Re: Register Reference No. 91A/1907;
5 no. 2-bed houses in lieu of three already approved houses at Woodfield,
Scholarstown Road, Scholarstown.

Register Reference : 91A/1907

Development : 5 no. 2 bed. houses in lieu of 3 already approved houses

LOCATION : Woodfield, Scholarstown Road, Scholarstown

DRG
 LAYOUT PLAN & SERVICES

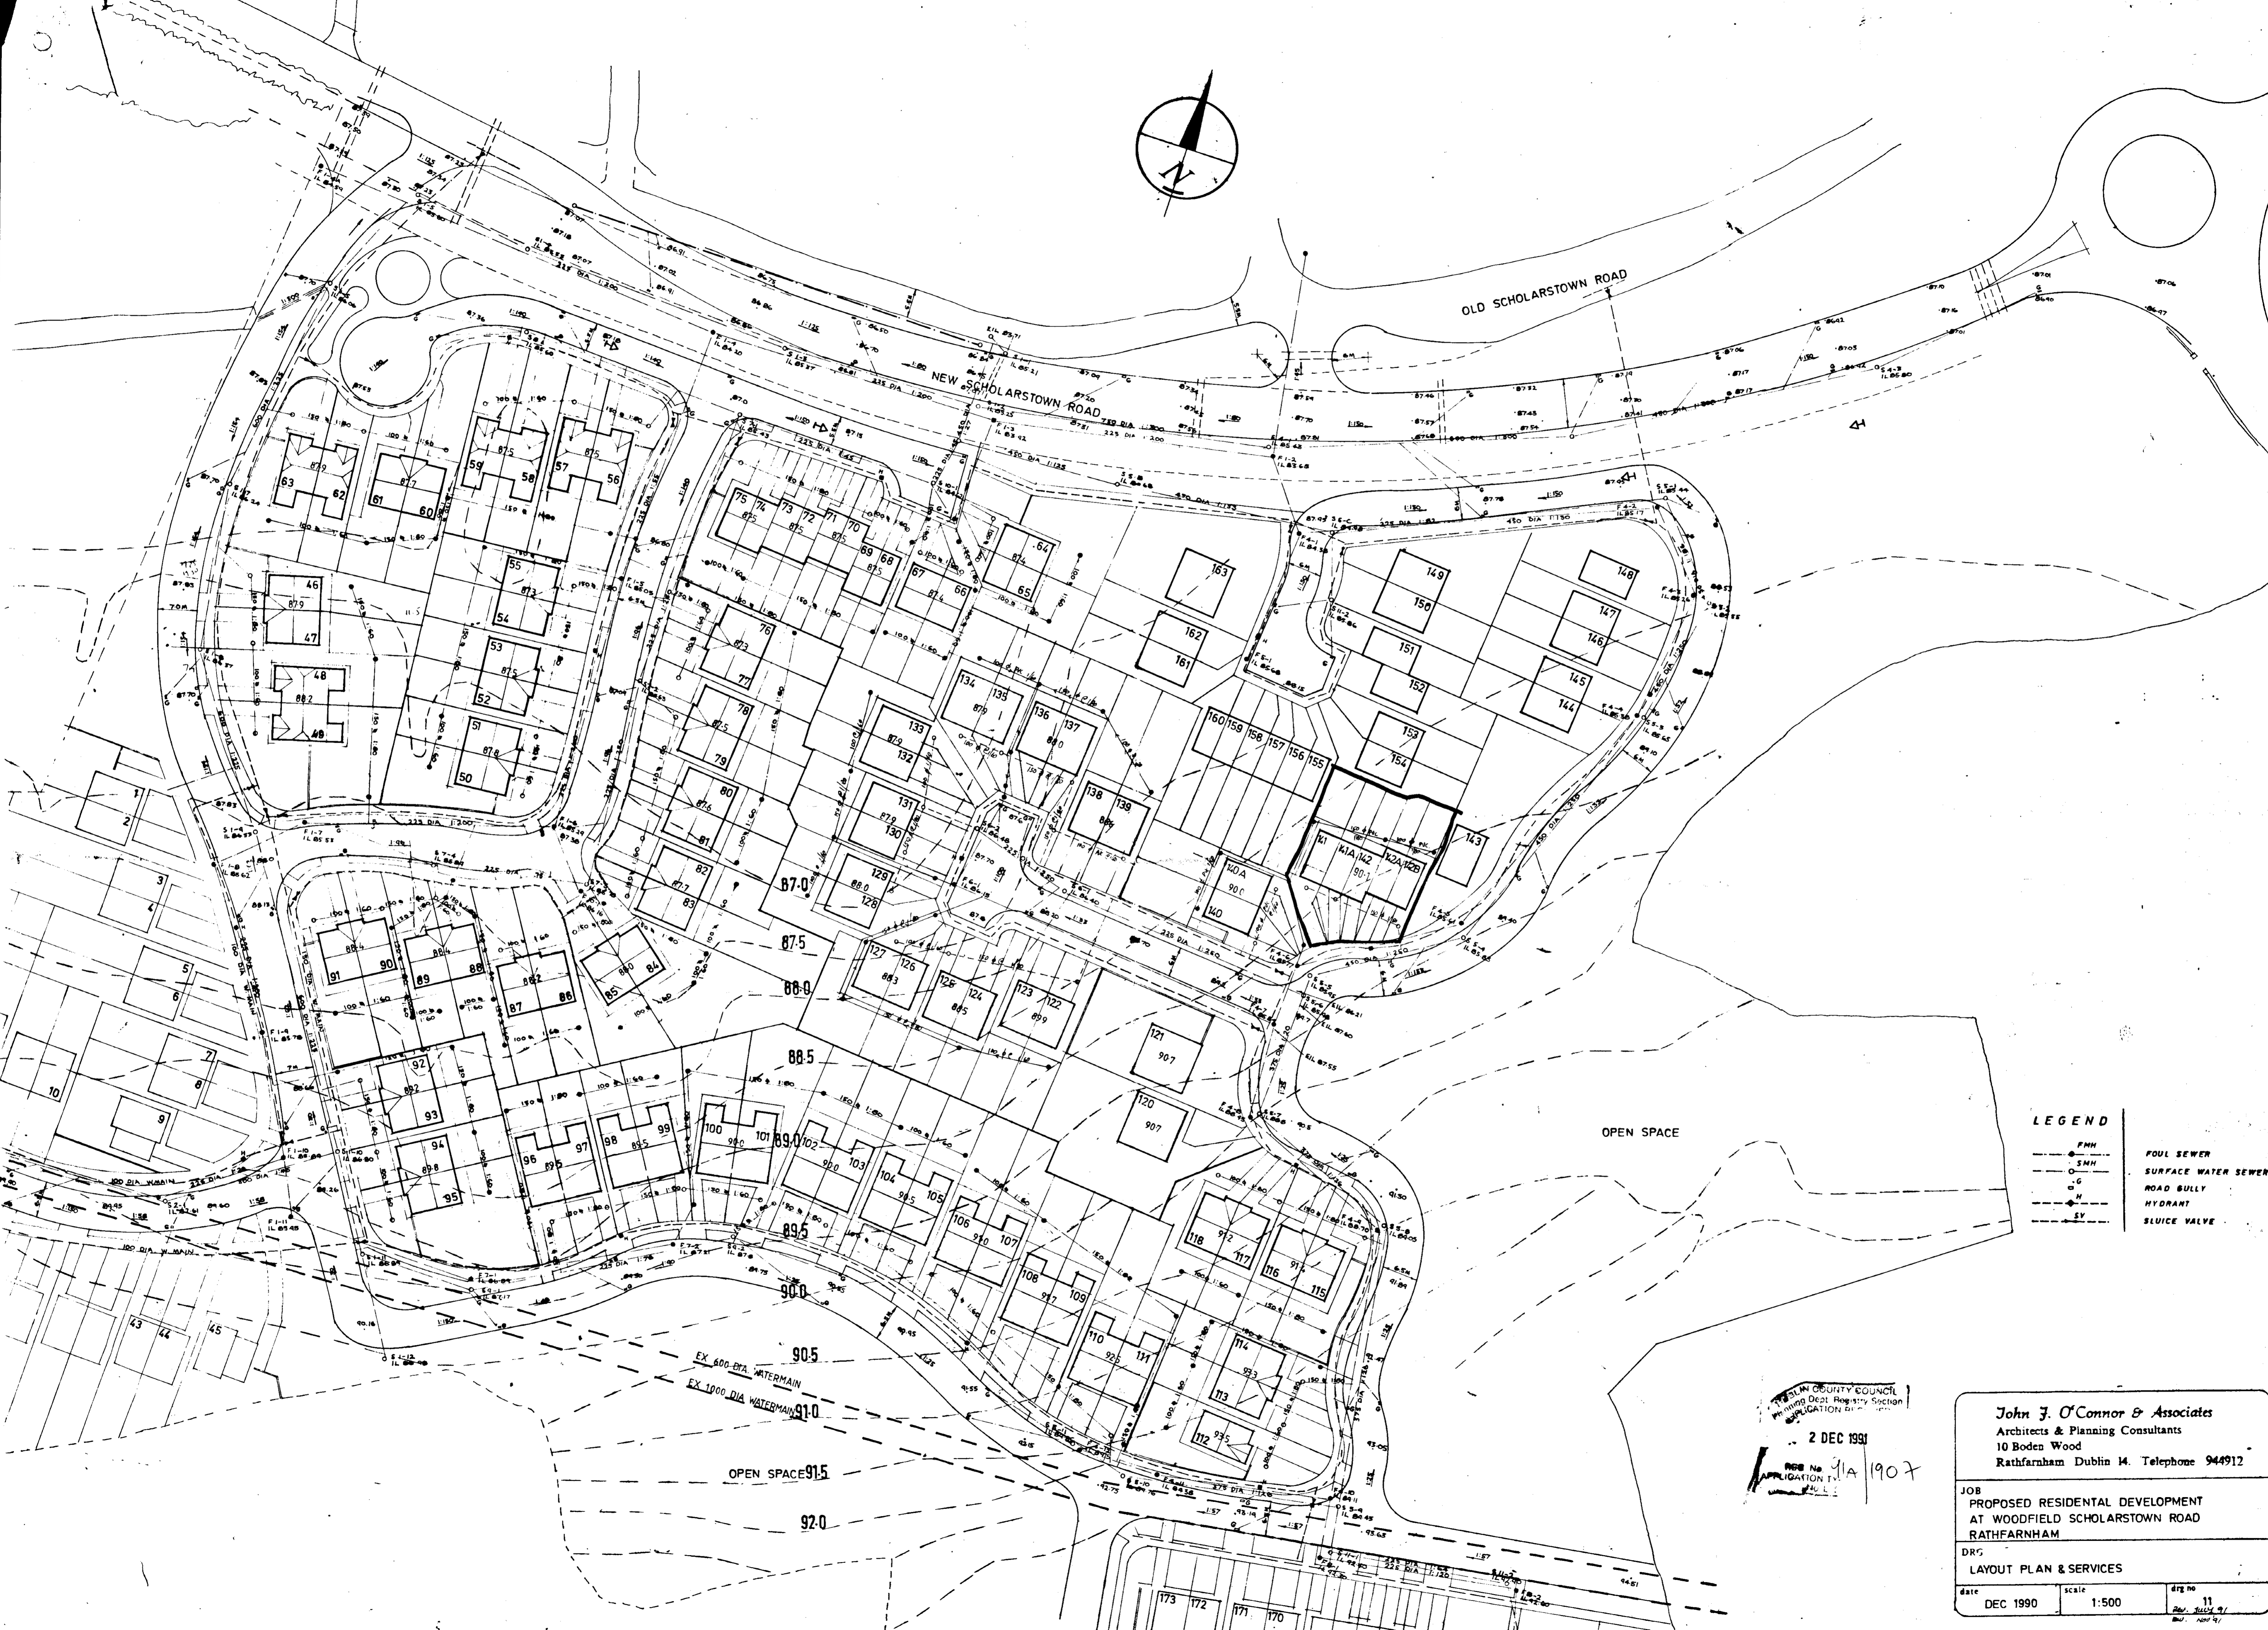
The dimensions of the proposed two bed houses as measured from the floor plans are 11.1 x 4.0 metres. The houses on the block plan of the site scale at c. 9.2 x 4 metres.

The proposed development cannot provide for adequate private open space to the rear. Gardens to the rear would be less than the required 10.7 metres in length which is unacceptable. Some of the driveways would also be less than the required 7.5 metres length.

The narrow road frontage of these 5 sites (c. 2.5 - 3 metres in width) would preclude on street car parking immediately outside these houses.

(a) There is a discrepancy between the dimensions of the houses as indicated on the floor plans and the scaled dimensions on the block plan of the site. The proposed houses measure 11.1 metres in depth, and not 9.2 metres as scaled on the block plan. The proposed development does not provide for adequate space around the dwellings in accordance with standards set out in the Dublin County Development Plan 1983.

(b) The gardens and driveways of all the dwellings would not be the required 10.7 metres (minimum) and 7.5 metres (minimum) in length respectively as set out in the Development Plan, and the proposed development would constitute substandard development and overdevelopment of this restricted site, and would, therefore, *seriously injure the amenities of property in the vicinity*.

This submission is over intensification of road frontage and proposes both inadequate vehicular access widths and parking. For developments of this nature roads require a minimum of 1.5 car spaces per dwelling i.e. one car space to be provided by the driveway and one on-street car space between adjoining driveways.

However, this submission could not provide any possible parking space between adjoining drives due to the density of the dwellings. In addition, at this particular location on-street car parking is not acceptable due to the horizontal alignment. Roads consider the original proposal of 2 semi-detached and 1 detached dwelling at this location as per approved application 90A/0324 to be preferable than the current submission, which would create hazardous on-street parking.
